USER SAFETY NOTICE

TO: USERS OF THE SCOTT AIR-PAK 75 SELF CONTAINED BREATHING APPARATUS

SN 09102012-2 Rev A

Figure 2- Air-Pak 75 WITH adjustable seats
SUBJECT OF THIS NOTICE

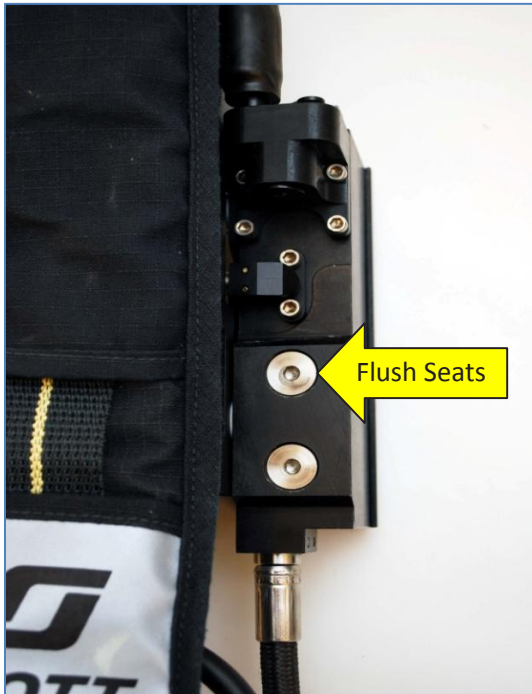
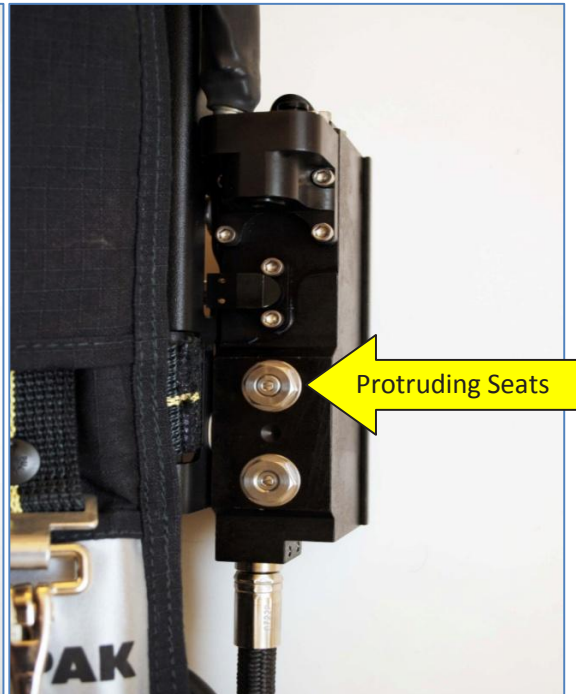
Figures 1 and 2 show the Air-Pak 75 reducers with and without adjustable seats. Only the reducers with protruding seats are subject to this notice.

If the manufacture date of your SCBA is between January 23, 2012 and April 15, 2012 you have one of these SCBA. The serial number label on the reducer contains the manufacture date. See instructions below for location of the label and date.

The Distributor Service Center or Scott will schedule the repair at no charge to you. If you have any questions, contact Scott Technical Service at 1-800-247-7257, ext. 3379 or through the website www.scottsafety.com.
